Justification for Stage 2 Amendments to R149 (RID) (Paragraphs 5.1, 5.2, 5.3 and 5.4)

Figure 2: proposal for points and segments in the passing beam

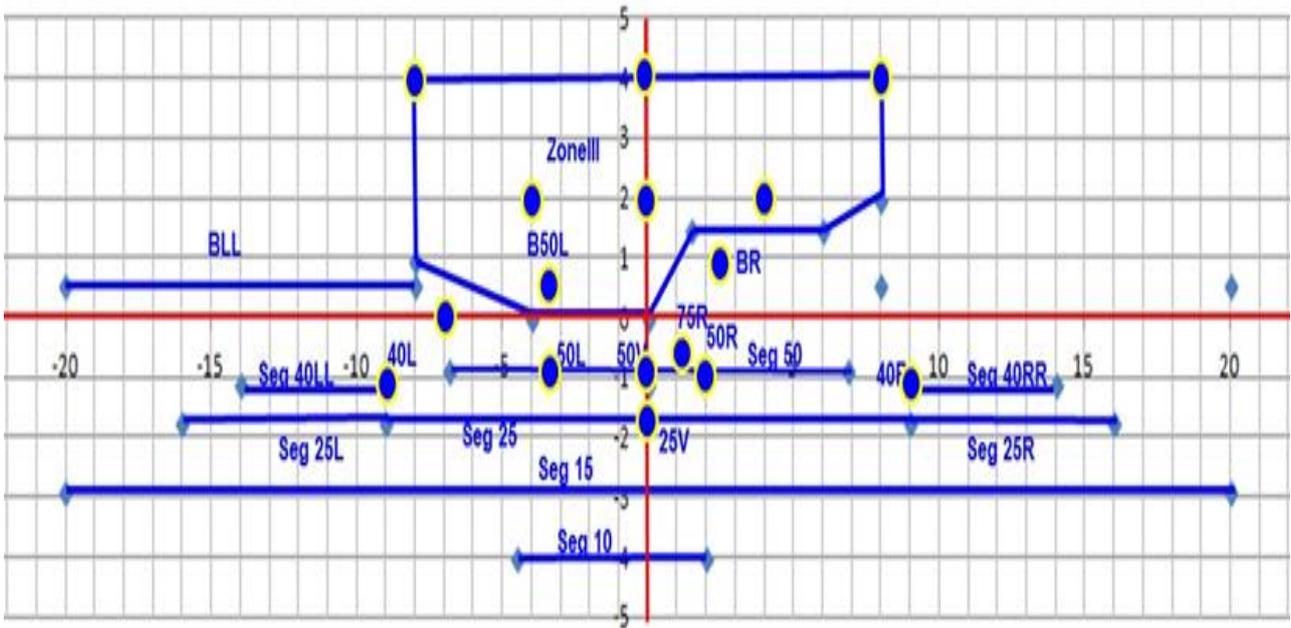
The existing photometric requirements of UN R149 have been taken into account along with the recommendations of TC4 -45 and SAE J2829 and have been merged into new tables incorporating the most relevant existing points or segments. Other requirements, for example, the new segments **40L** and **40R**, have been included based on recommendations of CIE TC4-45 (CE188-2010).

The target was to increase the performance of the passing beam without any increase of the glare values. Consequently, the minimum requirement at the 75R point has been increased by 20% to improve the visibility distance.

Furthermore, segments in the beam are defined to make sure that there is a continuous illumination along the width of the road. The minimum width of the beam pattern has been significantly increased.

Figure 3:
*The figure represents half of the sum of contributors installed on the vehicle.
 On the road, the system installed on the vehicle will provide at least the double of the values on the figures.*

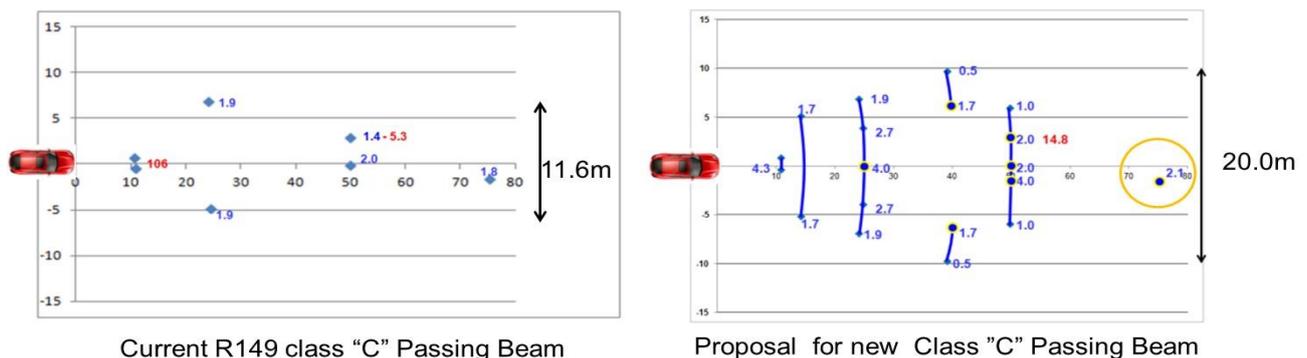
Figure 3 shows the correspondence between the points and segments of tables 8 and 9 and the corresponding positions on the road. It is the comparison between current class C passing beam and the new proposed grid. This comparison shows that the illumination on the road has been increased by 20% at 75m and the minimum width of the beam is roughly 20 m instead of 11.

Figure 4:

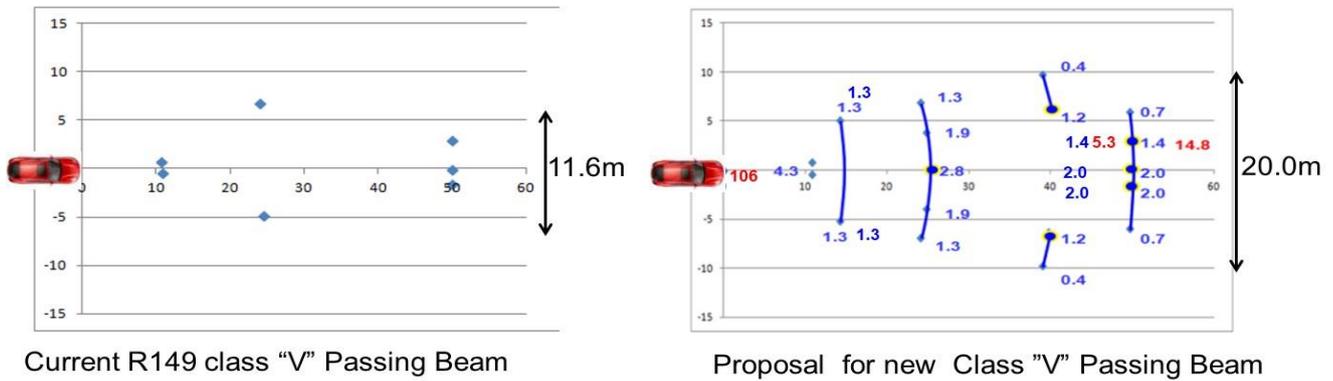
Tables of the current Class A passing beam and Class V passing beam have been merged in one single new table, Class A passing beam and Class V are both convenient for low speed vehicles and for urban areas. Figure 4 shows a comparison of the illumination on the road based on respectively current Class C passing beam and the proposed one. There is an improvement of the light distribution on the road without allowing any dark spots and a significant improvement of the width of the beam (20 meters instead of 12).

Figure 5.

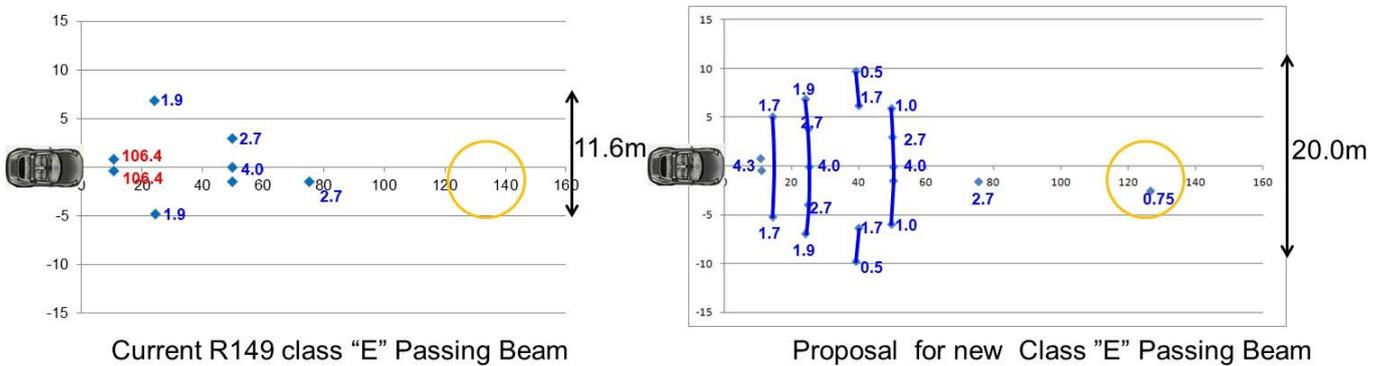
Figure 4 shows the comparison of illumination on the road of the Motorway Beam (Class E). The most relevant improvement is the introduction of the point 125R to ensure adequate illuminance on the road at a distance of 125m ahead. This corresponds approximately to the stopping distance of a vehicle moving at 120km/h

Figure 6.
Please refer to the foregoing explanation of this figure.

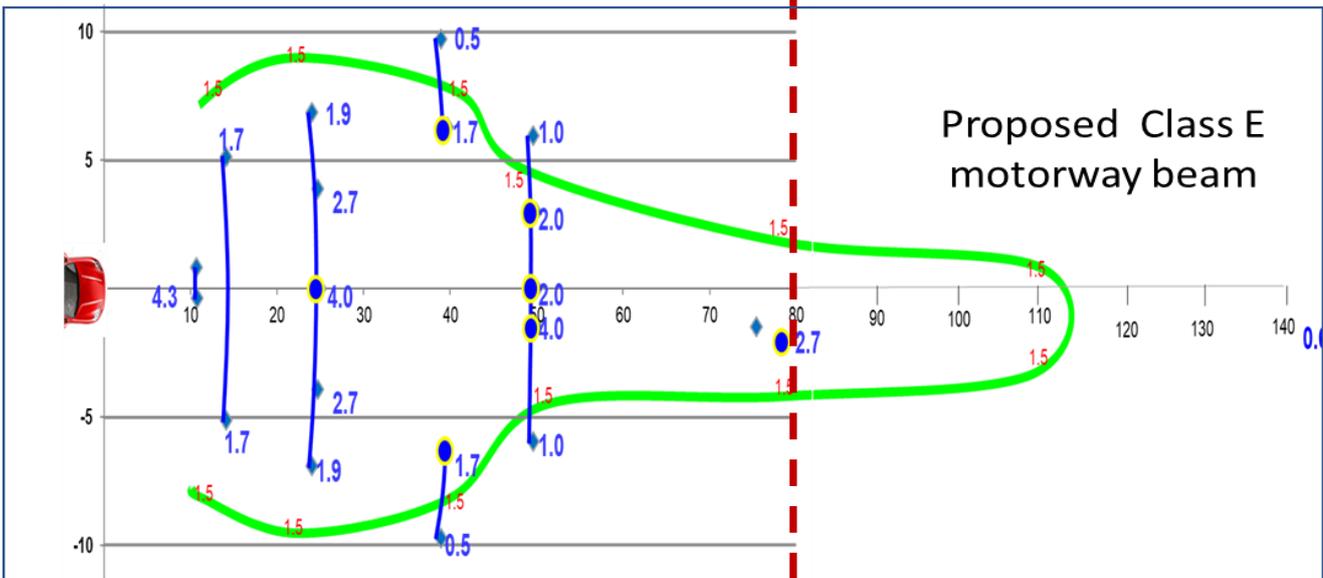
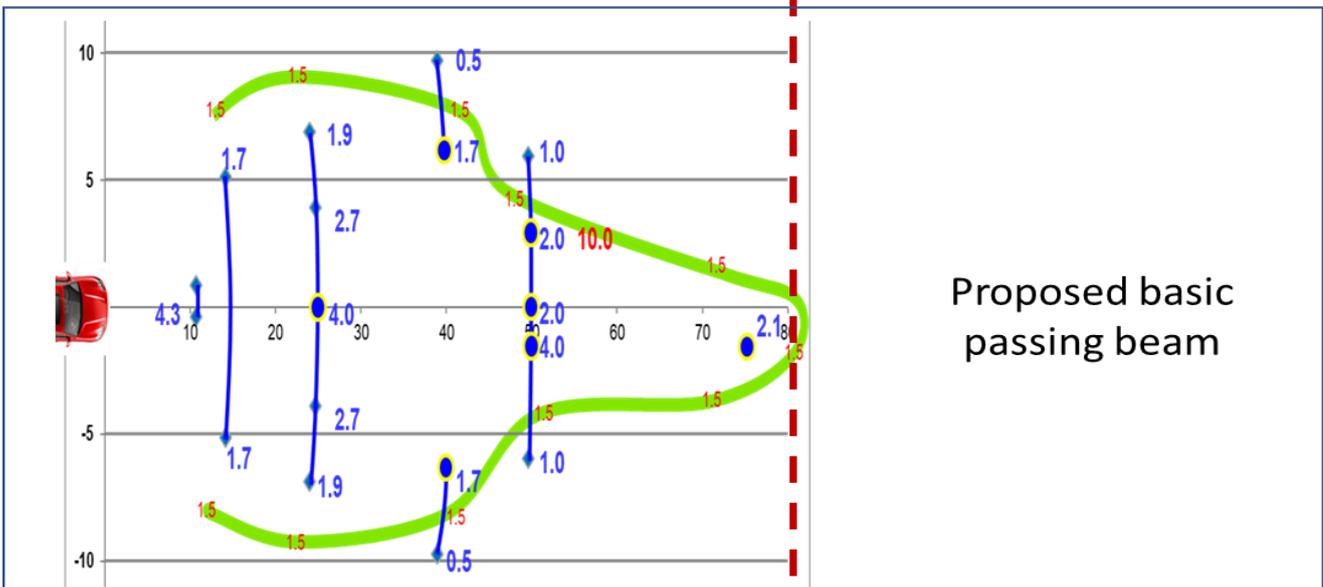
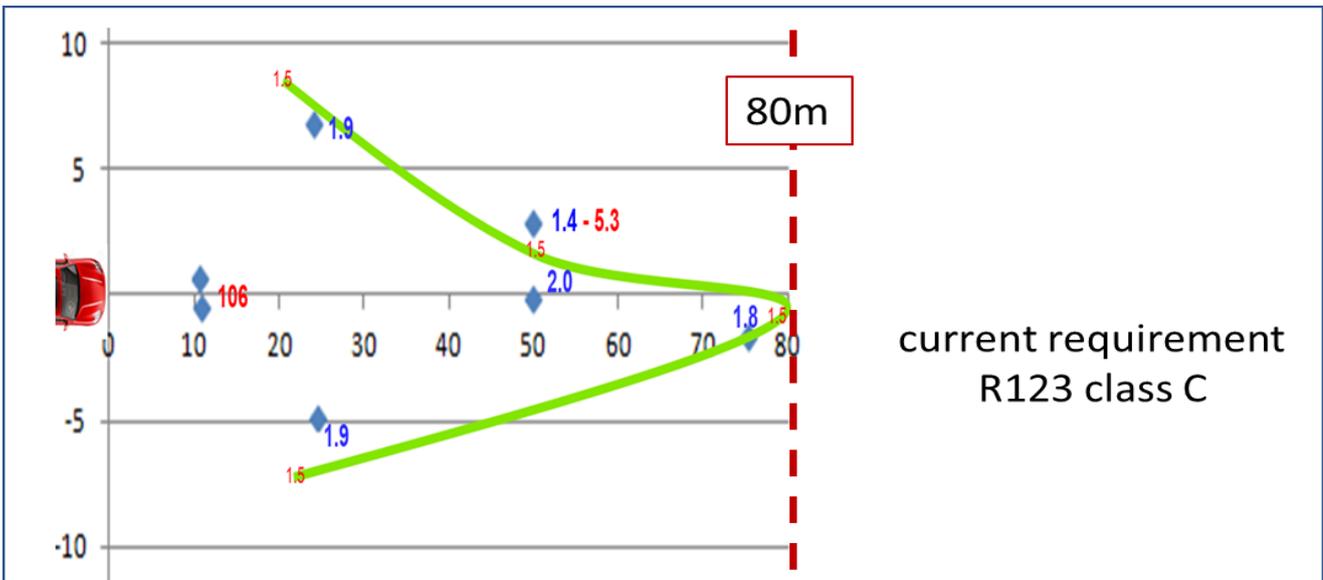
Following the accepted conclusion of CIE-TC4-45 that a luminance of 3.0 lux is required to identify the legs of a pedestrian the 1.5 isolux line is plotted on the road surface because only one half of the sum of contributors installed on the vehicle is shown.

- a) This isolux line is an estimation based upon the actual test points and values shown in figures 3,4 and 5.
- b) The green lines show the minimum performance of the class C and class E passing beams, assured by the proposed Stage 2 photometric requirements, in comparison with the current Class C of UN R149. However, these calculations assume that the devices are installed at a mounting height of 75cm and aimed at 1% down (0.57 degree).

The diagrams show that, when compared with the current R149 Class C photometric requirements, the proposed class C provides more width of the 1.5 lux minimum boundary up to a range of 80 m from the vehicle but this range cannot be exceeded because of the long-established balance between glare and visibility. In the case of the proposed class E passing beam the range increases to approximately 115 m because higher levels of can be tolerated, as established by UN R123 when AFS was introduced.

Figure 6

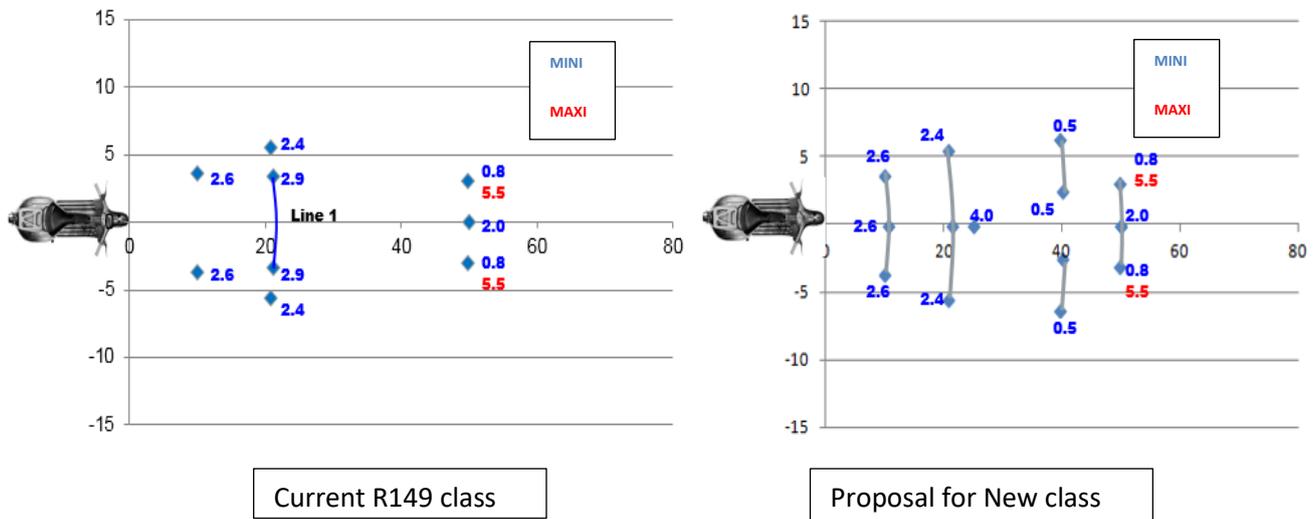
Comparison of the points and segments of Table 35 and the corresponding positions on the road as defined for Class DS in the adopted version of UN R149 and the proposed Class DS.

Figure 6 shows the safety benefit of the proposal, as in the 40 m range the width of the beam pattern is increased, the pedestrian detection will be improved. Additionally, the new proposal ensures homogeneous illumination by the introduction of segments.

Figure 7: Measurement grid comparison

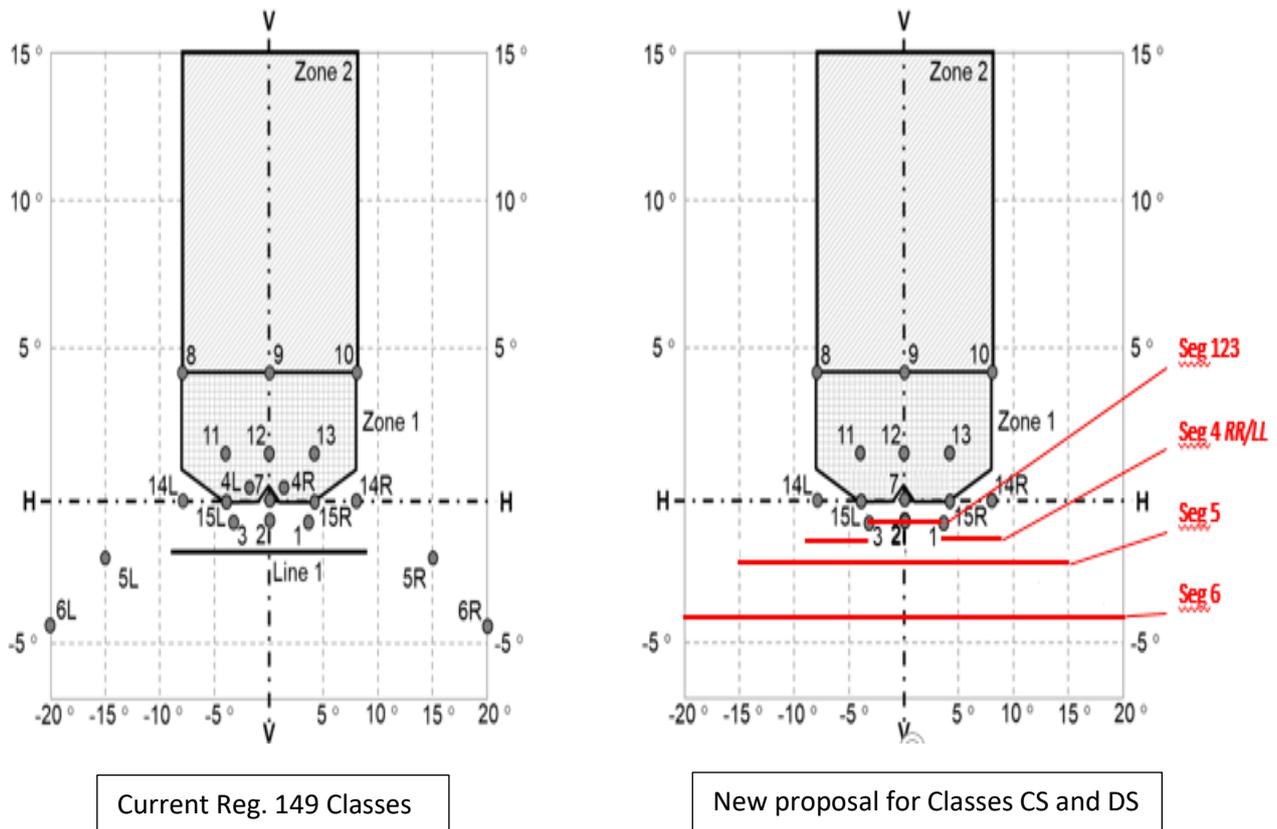
The following table explains the changes to the measurement grids shown in figure 7

Test points 1, 2,3 and 4	Segment 123 replaces the test points 1,2, 3 and 4 in order to avoid black Only the maximum values of test points 1 and 3 are retained, the minimum values are integrated in Segment 123.
Segment 4RR and Segment 4LL	These are new segments; they have the function to ensure that the illumination and homogeneity in the area 3-6 m offside for pedestrian detection (Zone C of CIE TC4-45). The luminous intensity for Class DS is from the Class C Basic passing beam proposal. The luminous intensity for Class CS is a half of the DS value.
Test points 4L and 4R	These points have been removed as they are integrated into Zone 1
Segments 5 and 6:	Segment 5 integrates line 1 and test points 5L and 5R into one segment and corresponds to 21 m ahead. Segment 6 integrates test points 6l and 6R into one segment and corresponds to 11 m ahead. These two segments ensure the illumination and homogeneity of widespread pattern [at 10 - 20 m] ahead for pedestrian visibility at intersections (Zone E of CIE TC4-45).

Test points 8 to 15 and zones 1 & 2	These remain unchanged

Figure 8: The repositioning of photometry points

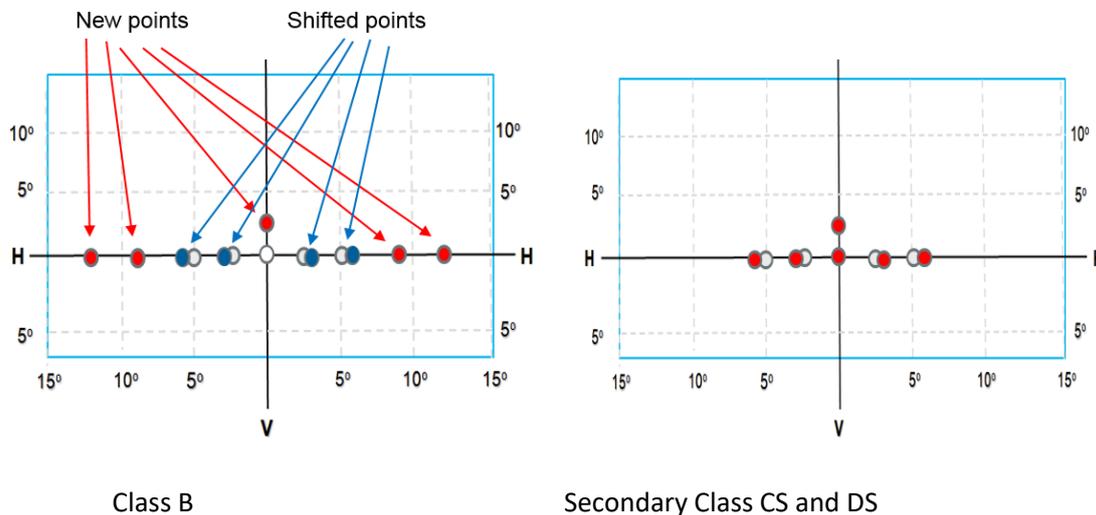
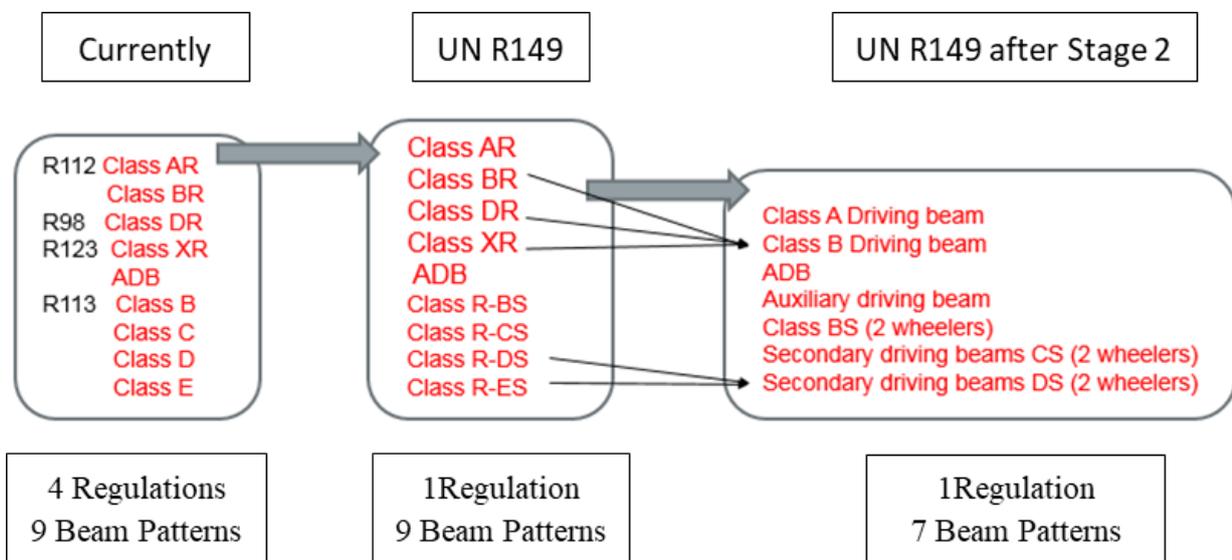
Additionally, the opportunity to harmonise with the US Safety Standard 108 has been taken, by aligning the angular position of all the existing test points and introducing 5 new test points. The new points at 9 and 12 degrees horizontally are introduced to assure improved visibility distance at the sides of the road and at 2 degrees above the H-V point. This assures a "minimum volume" of the driving beam. The details are shown in figure 8.
